Mr. Matthew A. Gelfand President, Universal Safety Response, Inc. 48 Arrandale Road Rockville Centre, NY 11570

In your July 24 letter to Mr. Richard Powers of my staff, you requested the Federal Highway Administration's (FHWA) acceptance of your Ground Retractable Automobile Barrier (GRAB) for use on the National Highway System (NHS). To support your request, you included a copy of a Texas Transportation Institute June 2001 report entitled "Testing and Evaluation of the Ground Retractable Automobile Barrier (GRAB): Tests 3 and 4" and video tapes of the tests that were conducted.

Figure 12. Summary of results for test 400001-USR3, NCHRP Report 350 test 2-30.

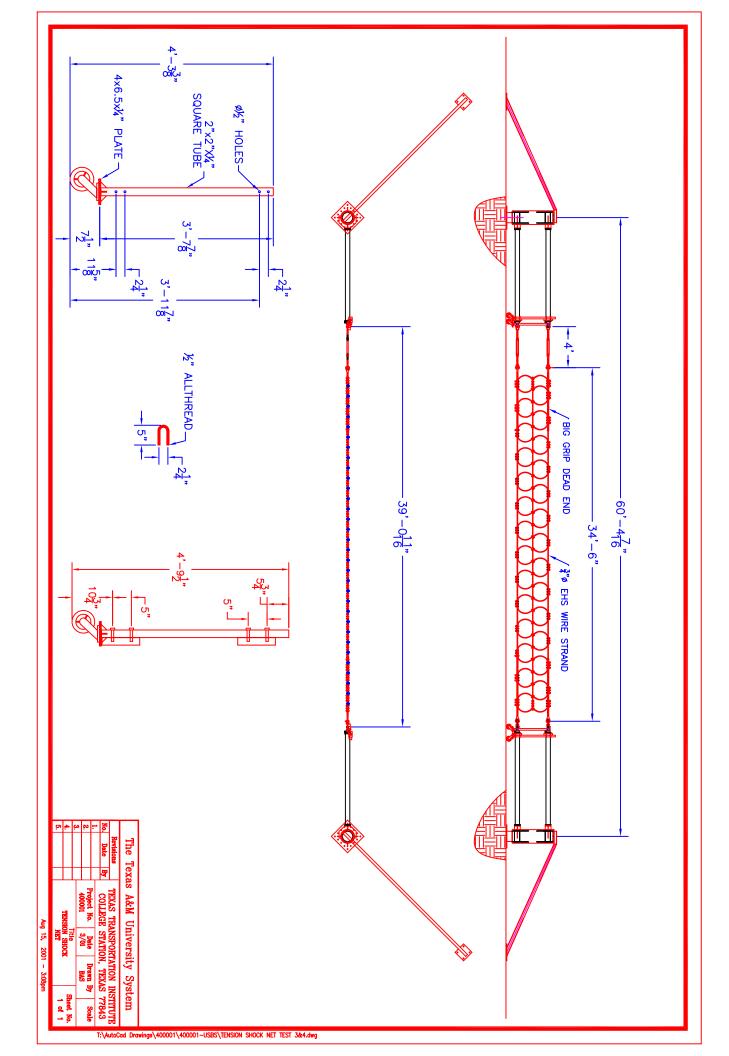
The GRAB was tested to the National Cooperative Highway Research Program (NCHRP) Report 350 test level 2 (TL-2), with both the 820-kg car and the 2000-kg pickup truck impacting at the third point of the net at a nominal speed of 70 km/h. Both vehicles were stopped smoothly with no significant roll, pitch or yaw. Occupant impact velocities for the car and truck were 6.1 m/sec and 5.1 m/sec, respectively. The corresponding 10-millisecond ridedown accelerations were 5.4 and 7.2 g's. Maximum dynamic deflection of the GRAB was 6.3 m with the car and 6.6 m with the pickup truck. Summary results for the two tests are shown in Enclosures 2 and 3.

Based on staff review and recommendations, I concur that the GRAB, as tested, meets the evaluation criteria for a TL-2 traffic gate and may be used on the NHS when its use is acceptable to the contracting authorities. This acceptance pertains to the tested installation (which was fixed) and assumes that the retractable unit will have comparable anchorage strength and performance characteristics. To verify this assumption, I will need to see final drawings for the retractable design when they are available. My acceptance is based only on satisfactory crash performance and is not intended to address the electrical or mechanical functioning of the GRAB. The final design should also be appropriately delineated, as discussed between you and Mr. Powers in a recent telephone conversation. Since the GRAB is a proprietary product, the provisions of Title 23 Code of Federal Regulations, Section 635.411 are applicable. A copy of this regulation is enclosed (Enclosure 4) for your reference.
